NYCT RADIATOR DOOR UPPER HINGE REPLACEMENT

Prevost vehicles

On the vehicles affected by this bulletin, the radiator door upper hinge must be replaced by a new improved hinge providing better door retention.

FIG.3 UPPER HINGE REMOVAL

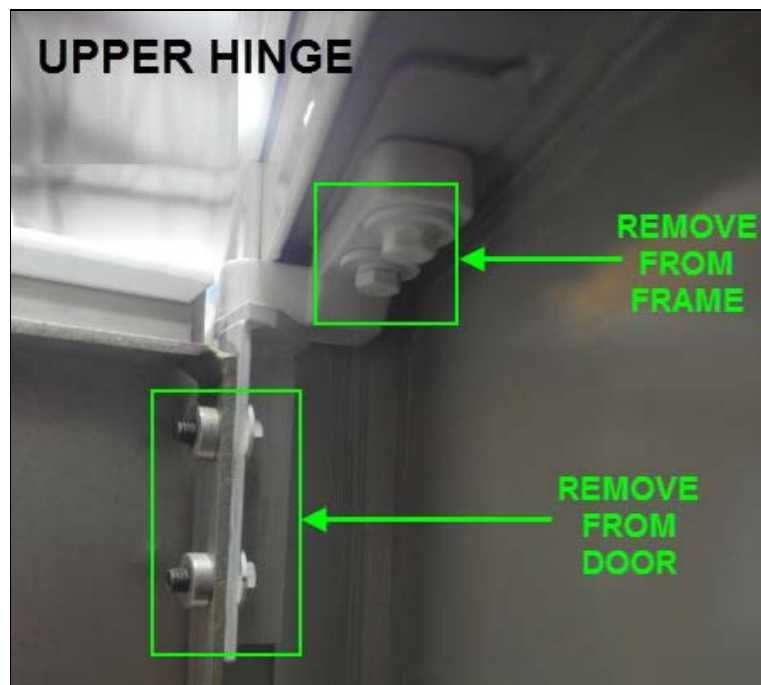
3. Unscrew and remove both parts of the upper hinge (4X M6 bolts at frame and door). Discard all parts and hardware (Fig.3).

FIG.7 NO GAP - UPPER HINGE

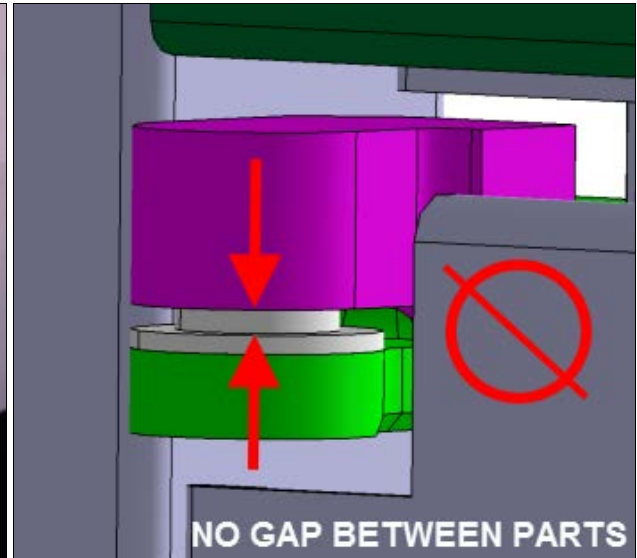
4. Install the new upper hinge (parts **280602**, **280609** & **280610** in kit Fig.4) making sure that:
- New M6 bolts and washers (**5000310** & **5001833**) are used at the upper (vehicle structure) mounting points (Fig.4).
 - New M6 bolts and washer (**502622** & **5001833**) are used at the door mounting points (Fig.4).
 - A new plastic bushing **284607** is installed at the pivot point (Fig.5).
 - The door is fully supported by the *lower hinge* and not slightly lifted-up by the lift table so there is no gap between parts at the lower pivot point (Fig.6).
 - There is no gap between the upper and lower part at the pivot point of the upper hinge (Fig.7).
 - Bolts are tightened snugly (do not apply final torque).

FIG.8 RADIATOR DOOR HORIZONTAL & VERTICAL GAPS

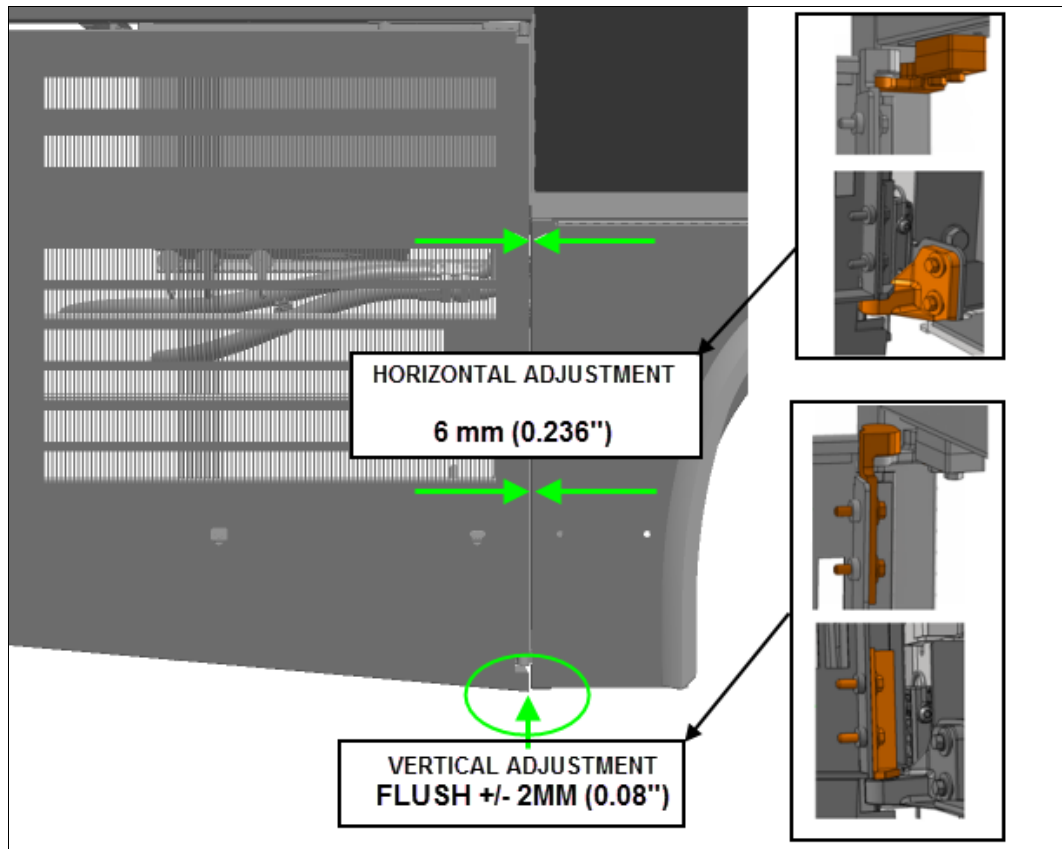
5. Remove door support installed at step 2 and open and close the door several times to make sure it is working properly, check door bottom and side adjustments. Bottom of the door should fit flush with the bottom of the fender (+/- 2mm) and there should be a 0.236" (6 mm) gap between the door and the vehicle rear fender (Fig.8).

If gap is out of spec the compressor door may be adjusted for proper fit by untightening hinge bolts:

- Loosen the bolts holding the hinge to the vehicle structure to shift the door horizontally LEFT or RIGHT.
- Loosen the bolts holding the hinge to the door frame to shift the door vertically UP or DOWN.

FIG.9 APPLY THREAD LOCKER, TORQUE & APPLY TORQUE SEAL

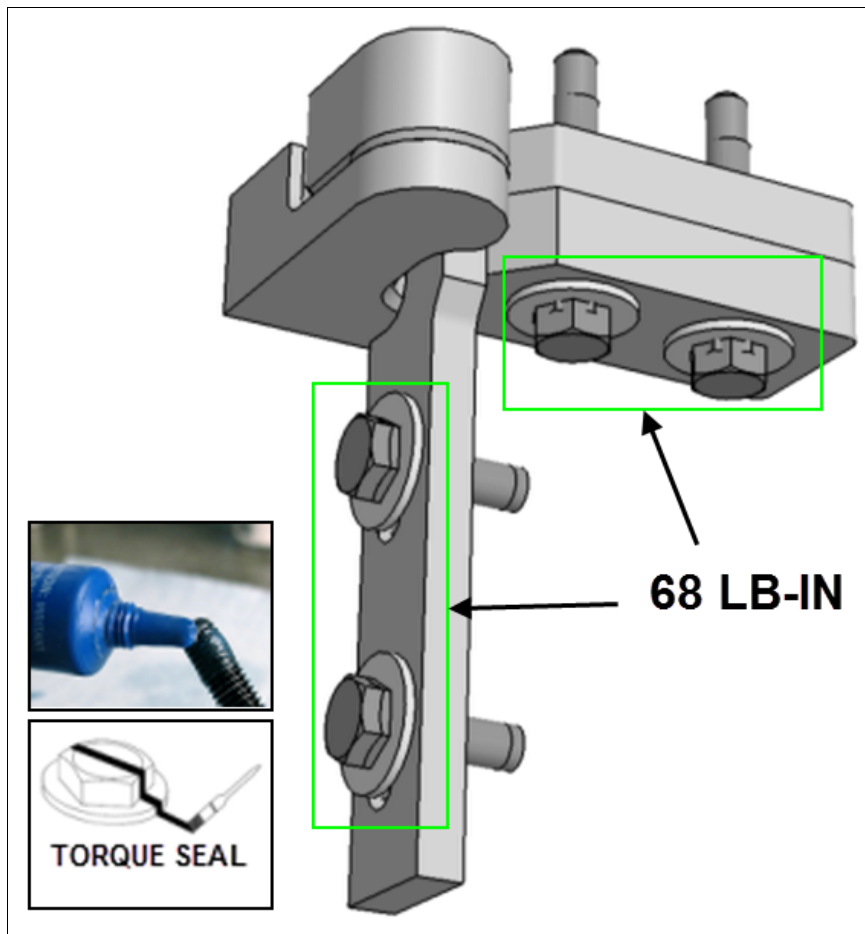
6. With the door gaps correctly adjusted, remove bolts and apply blue, *medium strength thread locker* (remove bolts one at the time – do not disturb adjustment), torque fasteners to the specified torque (**68 lb-in**) and apply a stripe of tamper proof indicator paint (torque seal) to all bolt heads (Fig.9).
